Pioneer Aircraft

Servo-Driven Trim Operating Rods

Fig. 1. This picture shows the broken actuator rod removed from the incident aircraft.

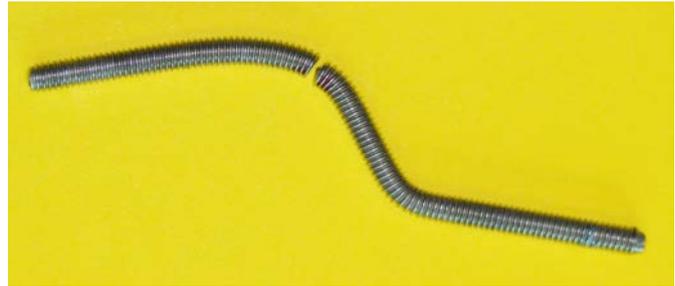
A recent incident involving a Pioneer 200 Microlight aircraft, where severe elevator vibration created handling difficulties during an otherwise normal take-off, was found to have been caused by the failure of the rod linking the servo to the trim tab.

Subsequent examination of the broken part has led to the belief that it is likely that this rod had been overstressed during its initial forming and had partially failed during manufacture; the part finally completely failing after approximately 100 hrs. in service.

The stainless steel trim rod that failed was coupled to a Ray Allen Servo and, to afford correct alignment between the servo and the tab, was bent in two places (see Fig. 1.) ... a practice cautioned against by Ray Allen in their installation instructions because of the potential for a serious reduction in the pushrod's strength.

One exacerbating factor was that the Pioneer trim operating rod was manufactured from threaded bar where the root of the thread was acting as a stress

Because of design similarity between the trim operating rods on all Pioneer aircraft, Airworthiness Information Leaflets (AIL) have been issued requiring all the trim rods to be changed to parts manufactured from un-threaded bar.
